HISTORIC AND DESIGN REVIEW COMMISSION

November 01, 2017

HDRC CASE NO: 2017-478
ADDRESS: 205 OSTROM
LEGAL DESCRIPTION: NCB 6938 BLK LOT 1&2
ZONING: R-4 CD H
CITY COUNCIL DIST.: 1
DISTRICT: River Road Historic District
APPLICANT: Tobias Stapleton
OWNER: Tobias Stapleton
TYPE OF WORK: Demolition with new construction of two residential structures and two accessory structures / Construction of an accessory structure
APPLICATION RECEIVED: October 13, 2017
60-DAY REVIEW: December 12, 2017
REQUEST:

The applicant is requesting conceptual approval to:

FINAL "AS-BUILT" SURVEY

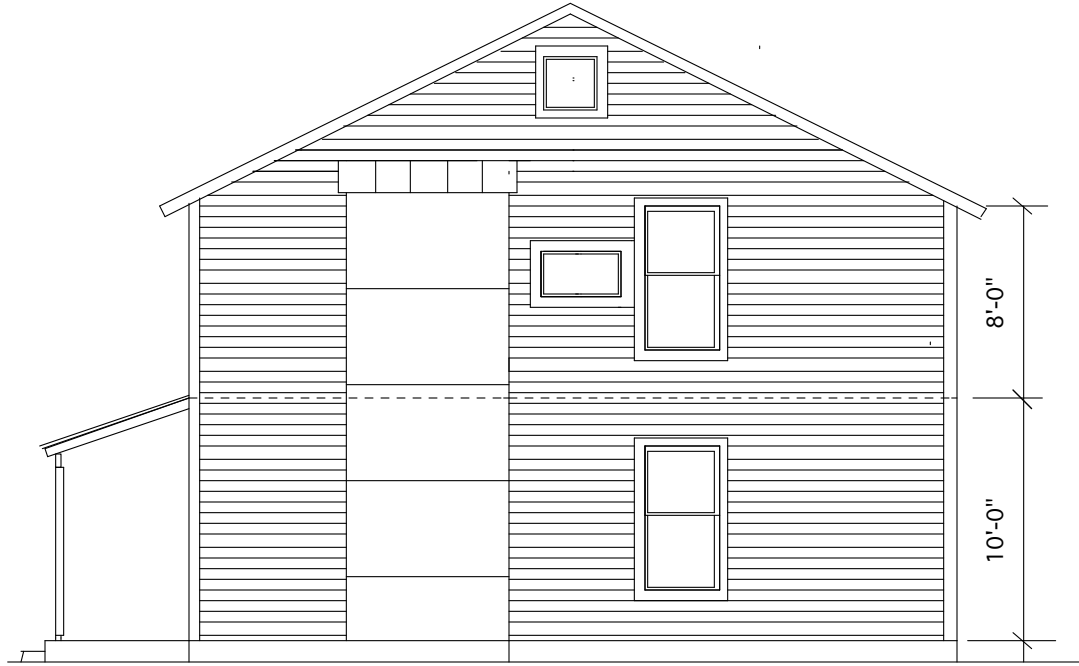
- 2b. **SETBACKS & ORIENTATION** – While the site plan provided is sufficient for conceptual review of design elements, concern has been expressed regarding the accurateness of the survey provided for the property and actual property lines may differ from those represented in the submitted site plan. Any final plans must represent accurate setback conditions and demonstrate compliance with the Unified Development Code prior to any request for a Certificate of Appropriateness.

- 3b. **SETBACKS & ORIENTATION** – While the site plan provided is sufficient for conceptual review of design elements, concern has been expressed regarding the accurateness of the survey provided for the property and actual property lines may differ from those represented in the submitted site plan. Any final plans must represent accurate setback conditions and demonstrate compliance with the Unified Development Code prior to any request for a Certificate of Appropriateness.

- vi. That a site plan with accurate setback dimensions and a tree survey must be submitted prior to an application final approval.

Front Elevation House Lot 1 scale: 1/8" = 1' - 0"

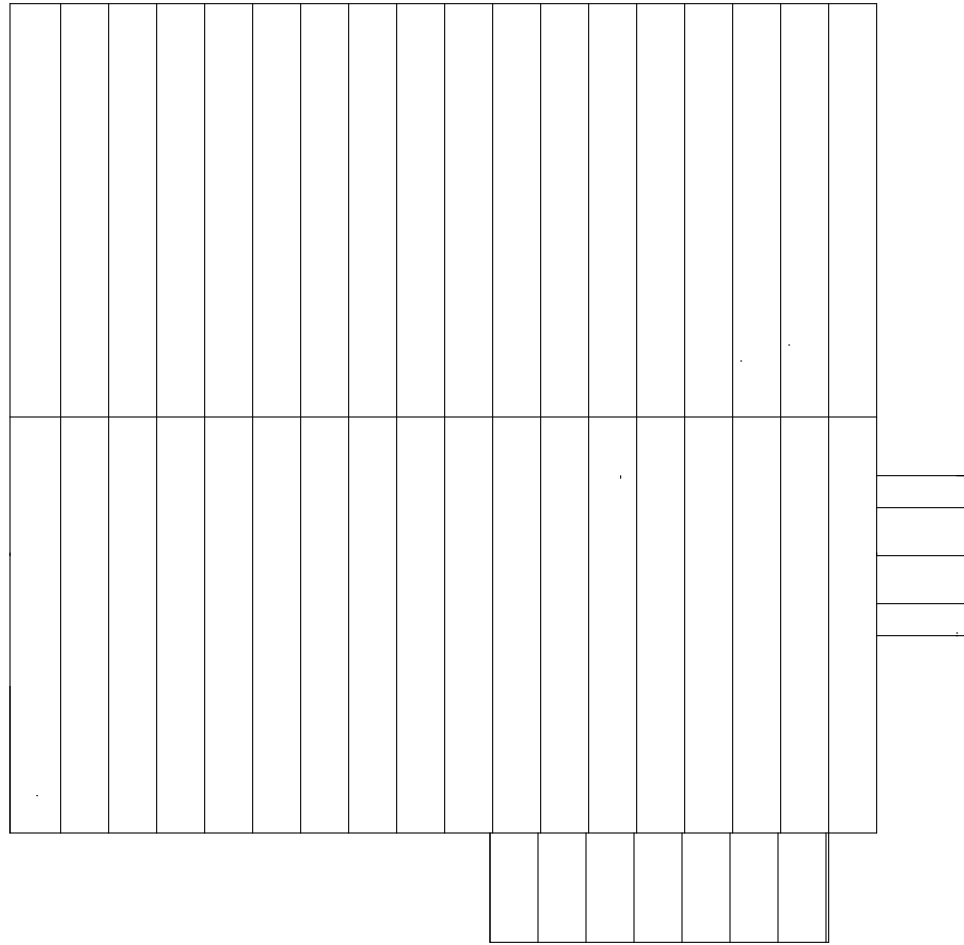
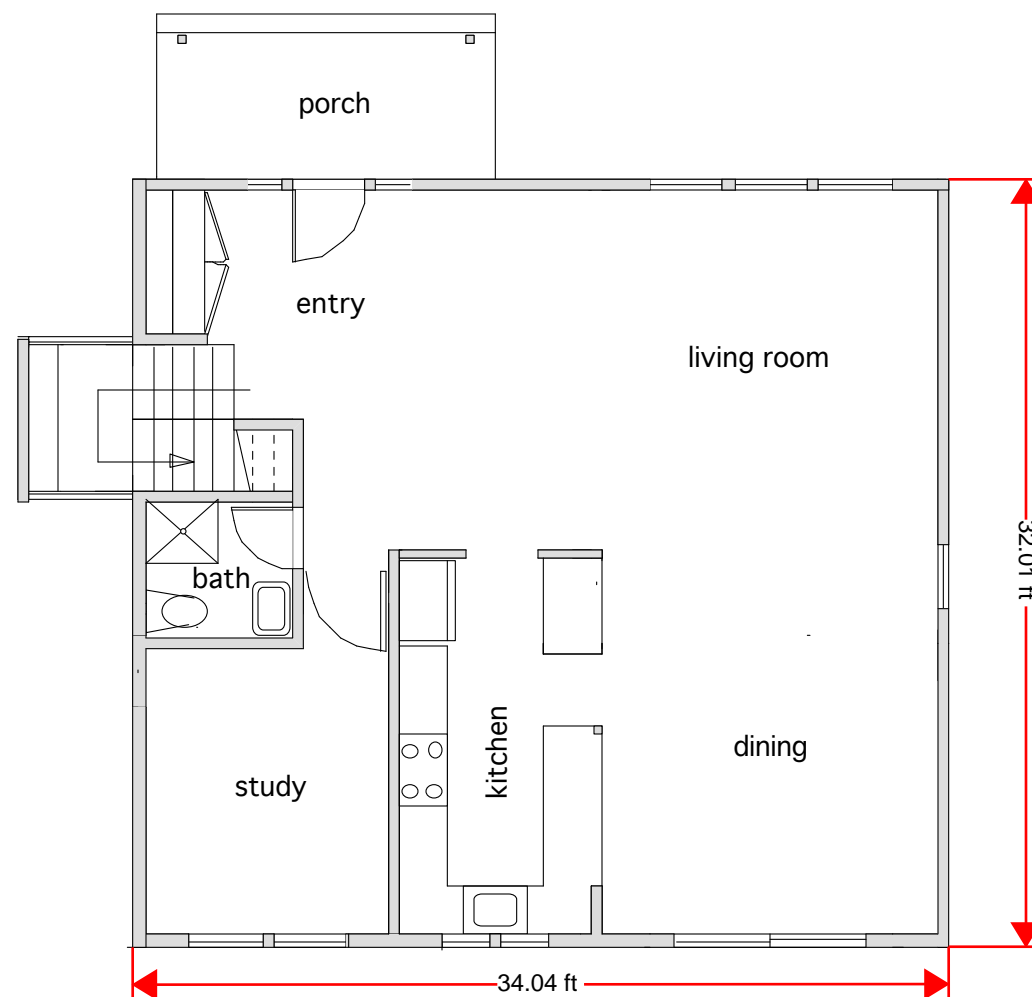
- 2e. **SCALE & MASS** – Per the Guidelines for New Construction 2.A.i., a height and massing similar to historic structures in the vicinity of the proposed new construction should be used. The applicant has proposed a two story structure with an overall height of 24' – 3". Many structures in the immediate vicinity feature either one or one and a half stories of height. While the applicant has proposed two stories, many of the neighboring structures feature additional height and steep pitched roofs. Staff finds the proposed height to be appropriate and consistent with the Guidelines.

- 2g. **ROOF FORM** – The applicant has proposed roof forms that include both front and side gabled roofs. Each street, Ostom, Magnolia Avenue and the intersection of the two will have a gable oriented towards them. Staff finds the proposed roof forms appropriate.

- 2j. **MATERIALS** – The applicant has noted the use of a standing seam metal roof and board and batten siding. Staff finds that the board and batten siding feature boards that are twelve (12) inches wide with battens that are 1 – ½" wide, that the standing seam metal roof feature panels that are 18 to 21 inches wide, seams are 1 to 2 inches in height, a crimped ridge seam or low profile ridge cap and a standard galvalume finish. A large profiled ridge cap shall not be used.

House Lot 2
First Floor Plan scale: 1/8" = 1'-0"

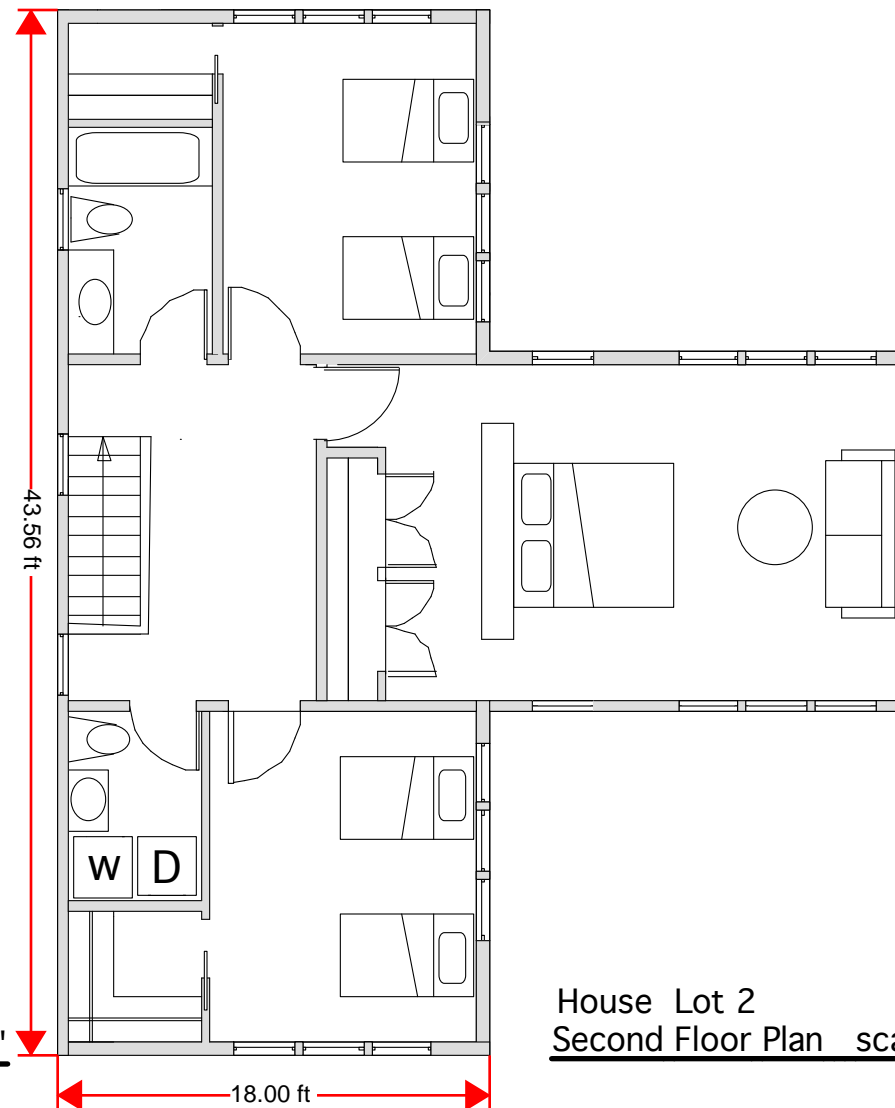
- 3g. **ROOF FORM** – The applicant has proposed to modify the previously proposed flat roof form to include a gabled roof, consistent with the Guidelines.

- 3j. **MATERIALS** – The applicant has noted the use of both vertical and horizontal siding; however, has not noted the material. Staff finds the use of wood or Hardi board siding to be appropriate; however, staff finds that the horizontally oriented Hardi siding should feature an exposure of four inches, that the board and batten siding feature boards that are twelve (12) inches wide with battens that are 1 – ½” wide.

- 3l. **ARCHITECTURAL DETAILS** – As previously noted, the applicant has proposed a flat roof in combination with horizontal and vertical siding. Typically, flat roofs that are found throughout the River Road Historic District feature Spanish Eclectic architectural detailing including decorative roof parapets. Staff does not find the proposed roof to be appropriate in relationship to the proposed materials and adjacent proposed structure. Staff finds that a second structure that matches the design of the structure in request item #2 would be more appropriate.

Accessory Buildings
Identical one on each Lot
Qty 2

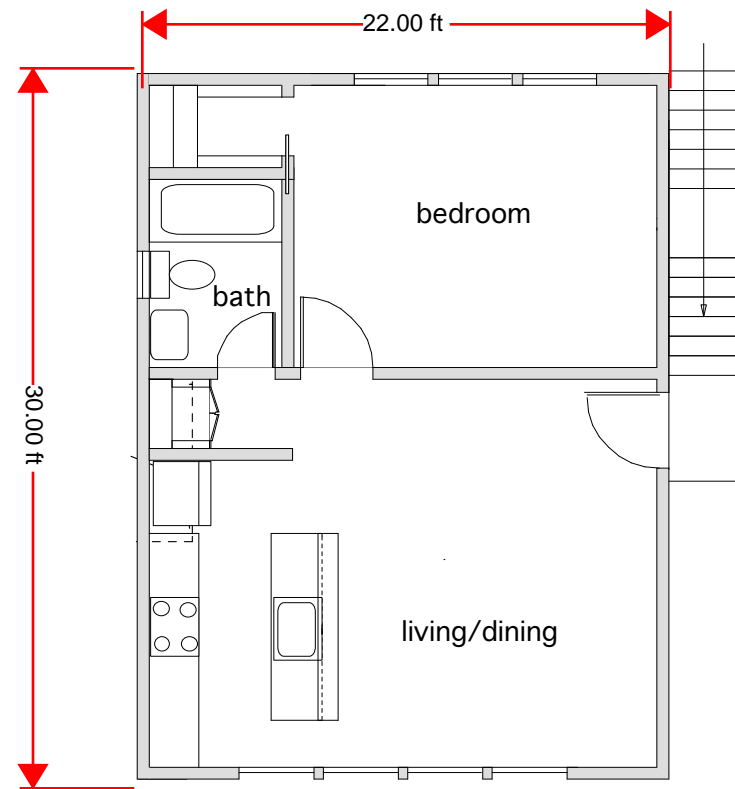
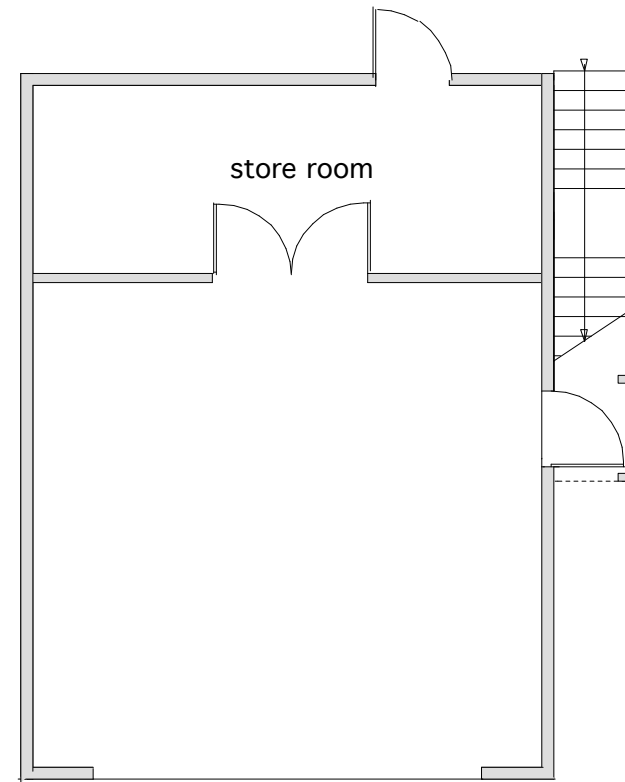
- 4a. ACCESSORY STRUCTURES – To the rear (west) of the structure noted in request item #2 and to the side (south) of the structure noted in request item #3, the applicant has proposed to construct two, two story accessory structures to accommodate vehicular parking as well as a second level dwelling unit. The proposed accessory structures feature an overall profile and massing that is subordinate to the proposed, primary residential structures, feature appropriately detailed garage doors and feature architectural detailing that's consistent with the historic examples found throughout the River Road Historic District. Staff finds the proposed accessory structures appropriate and consistent with the Guidelines.

DOUBLE HUNG SERIES 9200

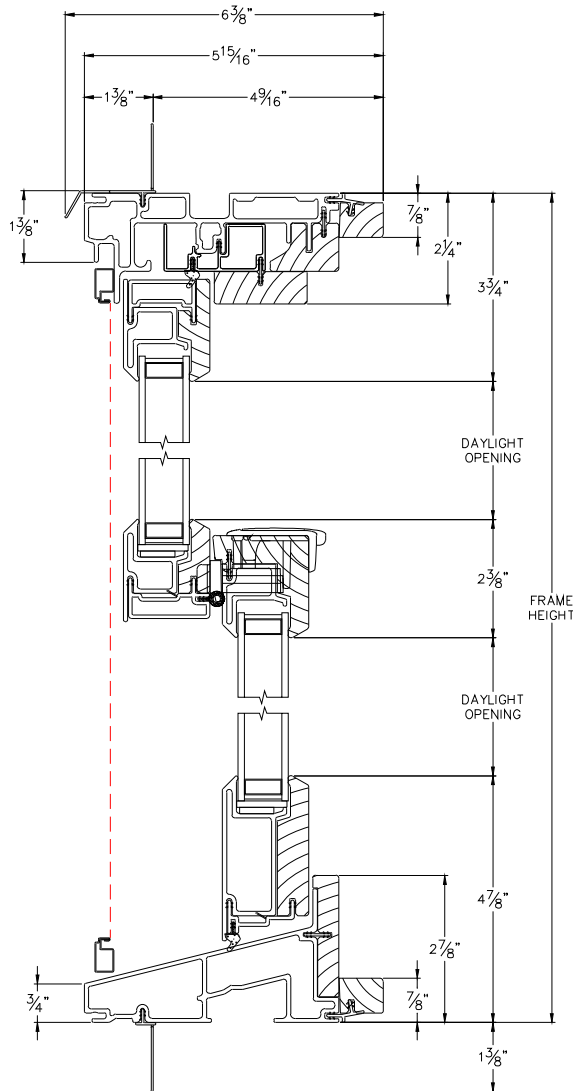
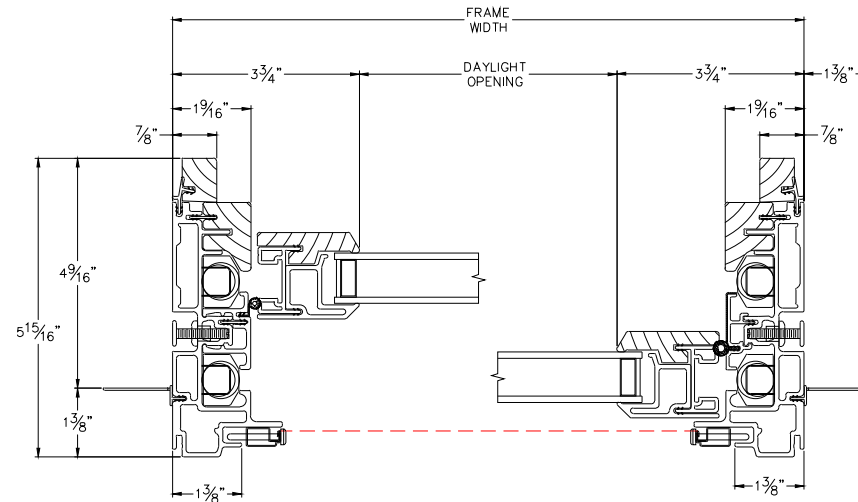
- 2k. **WINDOW MATERIALS** – At this time, the applicant has not provided information regarding window materials. Staff recommends the installation of wood windows that are consistent with the Historic Design Guidelines, Window Policy Document as noted in finding n that are to include traditional dimensions and profiles, be recessed within the window frame, feature traditional materials or appearance and feature traditional trim and sill details.

- 3k. **WINDOW MATERIALS** – At this time, the applicant has not provided information regarding window materials. Staff recommends the installation of wood windows that are consistent with the Historic Design Guidelines, Window Policy Document as noted in finding n that are to include traditional dimensions and profiles, be recessed within the window frame, feature traditional materials or appearance and feature traditional trim and sill details.

- ii. That the applicant install wood or aluminum clad wood windows should be installed that feature meeting rails that are no taller than 1.25” and stiles no wider than 2.25”. White manufacturer’s color is not allowed, and color selection must be presented to staff. There should be a minimum of two inches in depth between the front face of the window trim and the front face of the top window sash. This must be accomplished by recessing the window sufficiently within the opening or with the installation of additional window trim to add thickness. Window trim must feature traditional dimensions and an architecturally appropriate sill detail. Window track components must be painted to match the window trim or concealed by a wood window screen set within the opening.
